ATTACHMENT C

Thank you for the opportunity to review the Site and Preliminary Plan Applications (No. **820240090** and **120240070**, respectively) for the **7749 Old Georgetown Rd development**. The State Highway Administration (SHA) has reviewed the applications, and we are pleased to respond.

7749 Old Georgetown Road Preliminary Plan #: 120240070

RE: 7749 Old Georgetown Road

ACCESS PLAN

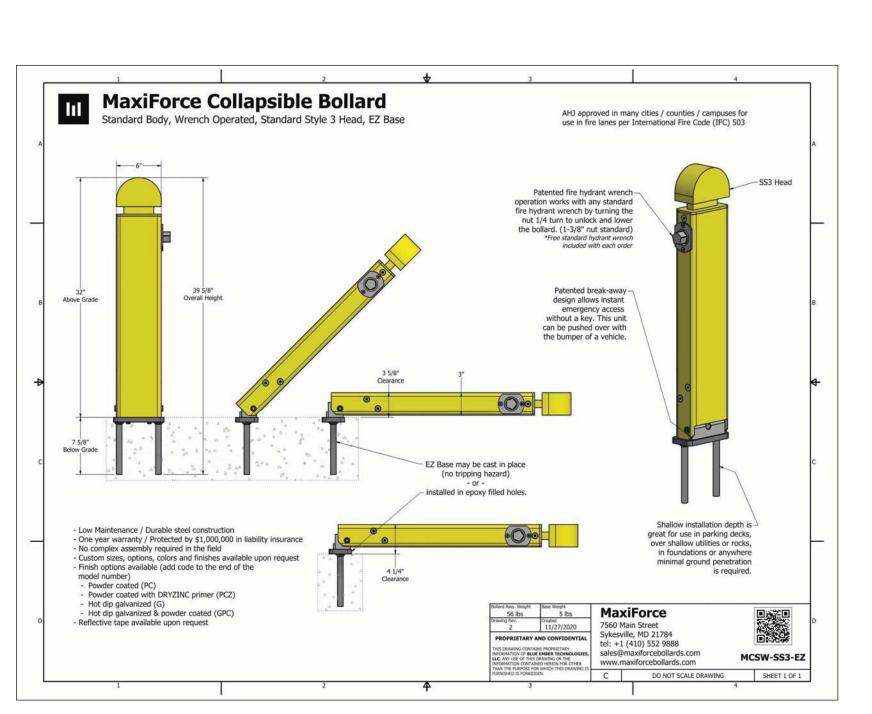
*** Collapsible bollards required for hydrant access shall be yellow or red, marking a fire lane ***
